RE: **Proposed McDonald's Restaurant**
Lot Consolidation and Driveway Access Permit Application
Block 23 – Lots 4 & 5
US Route 202 (Speedwell Avenue) (MP 46.58)
Borough of Morris Plains, Morris Co., NJ
A-202-N-58348-2025
LC-202-N-58347-2025
Denial Of Waiver Request

RE: **Proposed McDonald's Restaurant**
Lot Consolidation and Driveway Access Permit Application
Block 23 – Lots 4 & 5
US Route 202 (Speedwell Avenue) (MP 46.58)
Borough of Morris Plains, Morris Co., NJ
A-202-N-58348-2025
LC-202-N-58347-2025

The NJDOT SMEs have completed their first review of this application and have the following comments.

3. Original BPP comment: Site Driveway Design

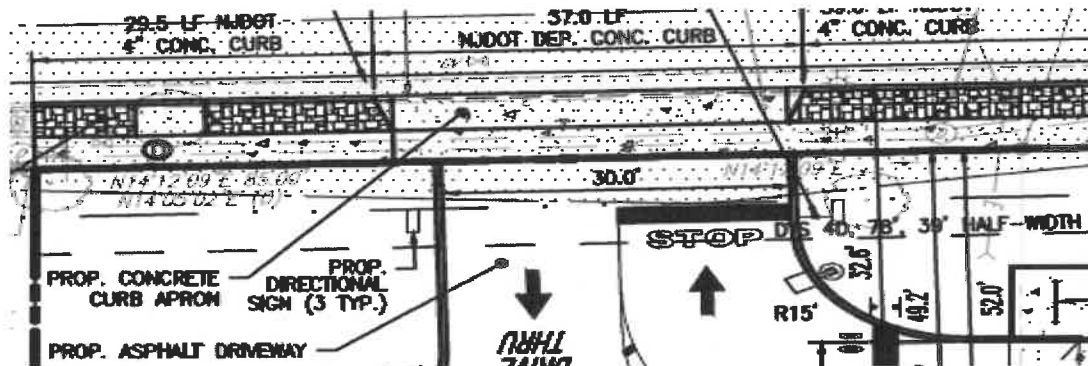
On Sheet 3 of the Site Plan, we are unable to confirm if the sidewalk continues across the site driveway along Route 202 NB. Please note, the design of driveways should provide a continuous and level pedestrian zone across the vehicular route to encourage drivers on their way in and out of the site to stop for pedestrians. Please continue the sidewalk across the proposed site driveways along Route 202 NB as indicated on pages 38-39 of the NJ Complete Streets Design Guide *or* provide a high-visibility, ladder-striped crosswalk and ADA-compliant curb ramps at the site driveway to ensure pedestrian pathway continuity.

Designer response: The sidewalk continues across the site driveway and vehicular access is proposed via a concrete apron in order to prioritize the pedestrian pathway.

BPP response: Thank you.
